Access Compliance Report

Public Rights-of-Way

Intersection ID: N/A	Main Street: CRAIGHEAD_RD	Cross Street: N/A	Location: W
ADA ID: 4E5BFBAE8526	Ramp Type: ParaDiag	Initial Pass/Fail: Fail	Overall Compliance: No
			Severity Score: 13.75

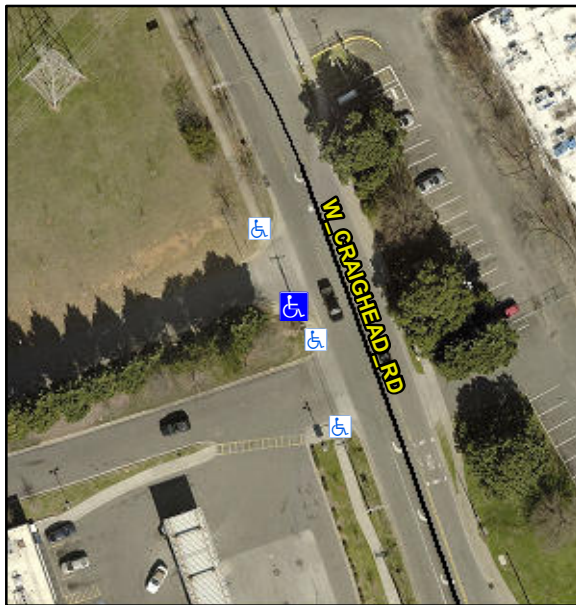
LT RP < 5%

R304.5.3, R304.3.2

Compliance	Description	Data	Compliance	Description	Data
N/A	Ramp Length LT (in)	49.0	N/A	Ramp Length RT (in)	62.0
Yes	Ramp Width LT (in)	60.0	Yes	Ramp Width RT (in)	60.0
Yes	Ramp Slope LT (%)	3.5	No	Ramp Slope RT (%)	9.3
No	Ramp XSlope LT (%)	2.2	Yes	Ramp XSlope RT (%)	1.9
N/A	Landing Length (in)	N/A	N/A	DWS Provided?	N/A
N/A	Landing Width (in)	N/A	N/A	DWS Contrast?	N/A
N/A	Landing Slope (%)	N/A	N/A	DWS Length (in)	N/A
N/A	Landing X Slope (%)	N/A	N/A	DWS Full Width?	N/A
N/A	Landing Curb? (Y/N)	N/A	N/A	DWS Offset (in)	N/A
N/A	Shared Landing?	N/A			
N/A	Gutter Ponding?	N/A	N/A	Gutter Slope (%)	N/A
N/A	Gutter Lip Ht (in)	N/A	N/A	Gutter X Slope (%)	N/A
N/A	Painted X Walk1?	No	N/A	Painted X Walk2?	No
	X Walk 1 Direction	To E		X Walk 2 Direction	To NW
N/A	X Walk 1 Width (in)	N/A	N/A	X Walk 2 Width (in)	N/A
	X Walk 1 Slope (%)	1.4		X Walk 2 Slope (%)	1.9
	X Walk 1 X Slope (%)	2.4		X Walk 2 X Slope (%)	1.0
N/A	Ramp inside XWalk1?	N/A	N/A	Ramp inside XWalk2?	N/A

Remove & Replace Curb Ramp With Two New Directional Ramps or Equivalent.
